Re: Warning Letter #WL20-207SW09SWD
OGC File No. 05-1078
Citrus County Class I Central Landfill
Facility ID: 39859
Citrus County

**Florida Department of
Environmental Protection
Inspection Checklist**

Facility Name: CITRUS CENTRAL SLF
On-site Inspection Start Date: 12/04/2020
On-site Inspection End Date: 12/04/2020
WACS No.: 39859
Facility Street Address: 230 W GULF TO LAKE HWY
City: LECANTO
County Name: CITRUS
Zip: 34461

Sept. '19 Topo. 160+ Elev. Ph. I

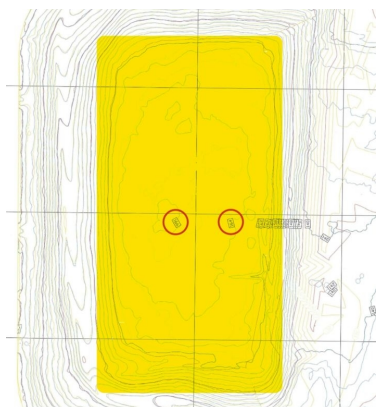
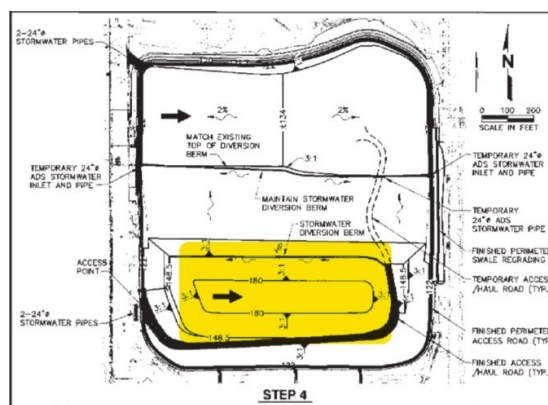
Explanation: A review of the 2019 topographic survey submitted to the Department with the latest annual estimate of remaining life report indicated that the elevation on the top of Phase I was 166 feet NAVD88 in September 2019, and the elevations of Phase II and III ranged between 120 and 140 feet NAVD88, respectively. At the time of the inspection, it appeared that the facility may not be filling the landfill in accordance with the fill sequence drawings included in the operation plan. Facility personnel indicated that Phase III was currently estimated to be around elevation 150 feet. As detailed in the fill sequence drawings, Step 4 should not have exceeded elevation 134 in Phases II/III and are brought up to elevations between 148.5 and 154.9 in fill sequence Step 5. However, during the inspection, it did not appear that waste between the elevations of 166 and 180 feet were observed in Phase I, which is also part of fill sequence Step 4. Discussion between the Department and facility personnel following the inspection indicated that a topographic survey of the facility was recently completed in September.

Corrective Action: Within 30 calendar days of the date listed on the attached letter, please provide the Department with a copy of the latest topographic survey of the landfill. In addition, please provide the following information to the Department:

- A) Photo documentation indicating that waste filling on the top of Phase I to elevation 180 feet has commenced and information detailing the approximate completion date of waste filling in this area, or;
- B) Documentation indicating if the facility would like to seek a permit modification to change the method and sequence of fill drawings and applicable sections included in the operation plan, and information detailing the facility's timeline to seek this permit modification.

C) Phase III - Sand Observed

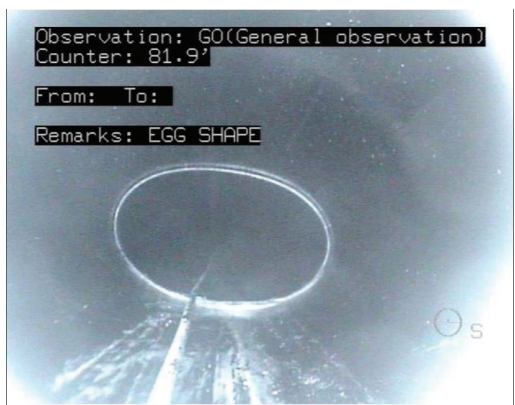
C) Per the Leachate Collection System Cleaning and Video Inspection Memorandum, four areas of pipe in which possible issues were encountered were observed. Two areas of pipe in which the camera stopped for unknown reasons are located in Phases II and III. The third area of pipe is also in Phase III. Within this area, sand is visible and caused the camera to stop. The fourth area of pipe is located in Phase IA and it was observed that the pipe is partially crushed, therefore causing the camera to stop. During the inspection, Department staff observed limestone within the onsite borrow pit. Based on the images provided by the leachate cleaning and inspection report, it is possible that calcification could be occurring within this area of the leachate system. In addition, Jones Edmunds indicates in this memorandum that the Phase IA pipe has become more constricted since 2015, and that more sand has accumulated in Phases II and III since 2015. The Jones Edmunds Cleaning and Inspection Memorandum indicates that additional investigation of these two areas is warranted.

C) Please provide documentation demonstrating if calcification could be occurring within the third area of pipe described above. Please also continue to evaluate the pipe construction in Phase IA and the sand accumulation in Phases II and III.
